# Access Compliance Report

## Public Rights-of-Way

### (Curb Ramps)

Intersection ID: 22832	Main Street: IMPERIAL_OAK_LN	Cross Street: OAKBRIAR_LN	Location: S
ADA ID: 177629239281	Ramp Type: Perp	Initial Pass/Fail: Fail	Overall Compliance: No
Severity Score: 25			
Codes/Mitigation Info/Possible Solution		Field Measurements/Component Compliance

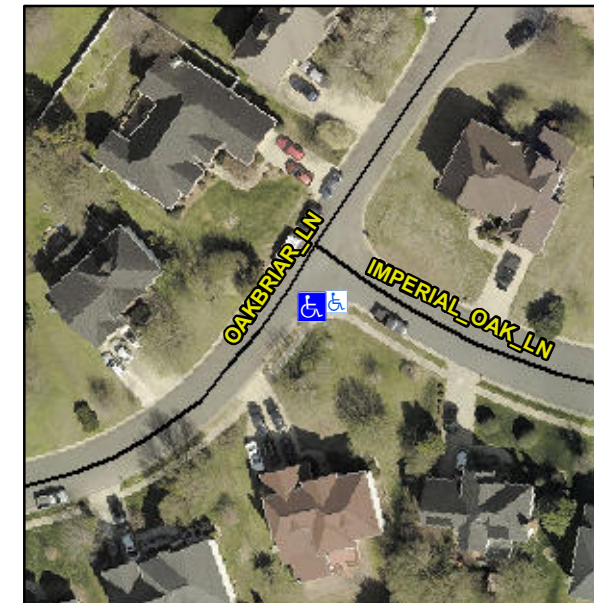
**Not Found, R304.2.2**

Compliance	Description	Data	Compliance	Description	Data
N/A	Ramp Length (in)	45.0	No	Ramp Slope (%)	13.9
Yes	Ramp Width (in)	48.0	Yes	Ramp XSlope (%)	1.6
N/A	Flare Type LT	N/A	N/A	Flare Type RT	N/A
N/A	Flare Slope LT (%)	N/A	N/A	Flare Slope RT (%)	N/A
N/A	Flare Traversable LT?	N/A	N/A	Flare Traversable RT?	N/A
N/A	Landing Length (in)	N/A	N/A	DWS Provided?	N/A
N/A	Landing Width (in)	N/A	N/A	DWS Contrast?	N/A
N/A	Landing Slope (%)	N/A	N/A	DWS Length (in)	N/A
N/A	Landing X Slope (%)	N/A	N/A	DWS Full Width?	N/A
N/A	Landing Curb? (Y/N)	N/A	N/A	DWS Offset (in)	N/A
N/A	Shared Landing?	N/A			
N/A	Gutter Ponding?	N/A	N/A	Gutter Slope (%)	N/A
N/A	Gutter Lip Ht (in)	N/A	N/A	Gutter X Slope (%)	N/A
N/A	Painted X Walk1?	No	N/A	Painted X Walk2?	N/A
	X Walk 1 Direction	To NW		X Walk 2 Direction	N/A
N/A	X Walk 1 Width (in)	N/A	N/A	X Walk 2 Width (in)	N/A
	X Walk 1 Slope (%)	5.5		X Walk 2 Slope (%)	N/A
	X Walk 1 X Slope (%)	1.7		X Walk 2 X Slope (%)	N/A

**Remove & Replace Entire Ramp.**
